I have read your manuscript with great interest. There is no doubt that this unique data set needs to be published (16! ADCPs over a period of 6 months, including a storm season). I am however not sure whether the chosen format is the best. You might consider changing the manuscript to a hydrodynamics-only paper. Leaving out the somewhat artificial way of dealing with sediment transport (a power of the velocity and neglecting waves) gives some more room for detailed analyses of the hydrodynamics. As indicated below, my main suggestions are related to the discussion part (the mass balances for cross shore and longshore). I hope these suggestions help in improving the paper.

General remarks

Figure 1 Alongshore and cross-shore current at highest locations on the field site.

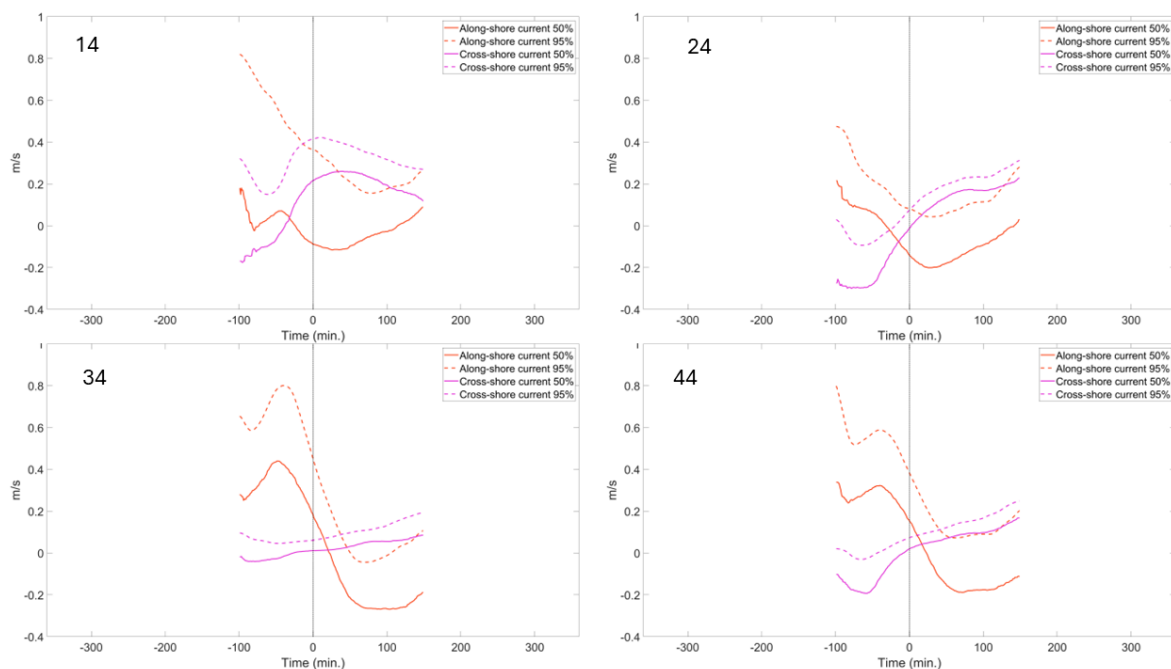
L175-185 The peak flow around 50-60 min before high tide is likely a peak in longshore velocity. The peaks at 14 and 24 will likely have a cross-shore component too. This could be more emphasized here or in the discussion on the flow bending around the higher area in the west. The description in this part is somewhat unsatisfying, as it is not fully clear why these phase shift are given. Are they to be discussed in the discussion?

Reply: the phase shifts are given to indicate that the flow differs along the field site. We agree that this could indeed be more emphasized, therefore we suggest the following change of the text:

Peak flood flow is typically reached 50-60 minutes before high tide which is in agreement with the peak flow in the alongshore direction. The exceptions are locations '14' and '24'. At these two locations a clear peak during flood is missing: the flow is maximum at the moment the sensor is flooded and subsequently decreases. At both locations the cross-shore component has a considerable effect on the current magnitude as is shown in Fig. 1 of this reply.
